REMINGTON, VERNICK & VENA ENGINEERS

SUMMARY OF QUESTIONS & RESPONSES

SUBJECT: Public Meeting – Bayfront Hazard Mitigation Project

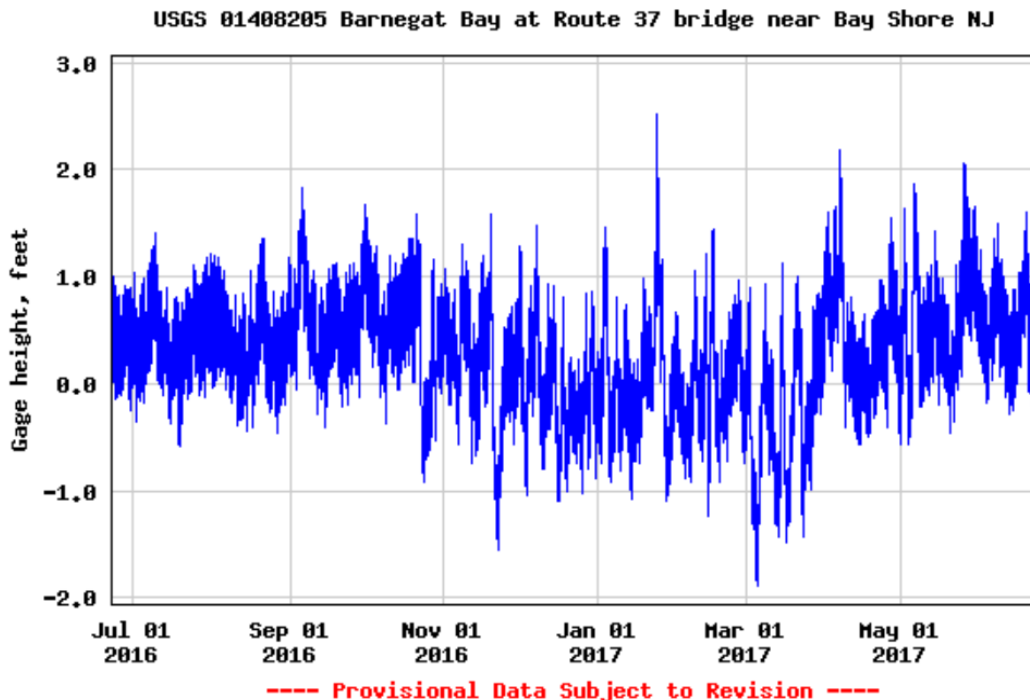
Question: Is the County still going to maintain the bulkhead?

Answer: Yes the County will own and maintain the bulkhead.
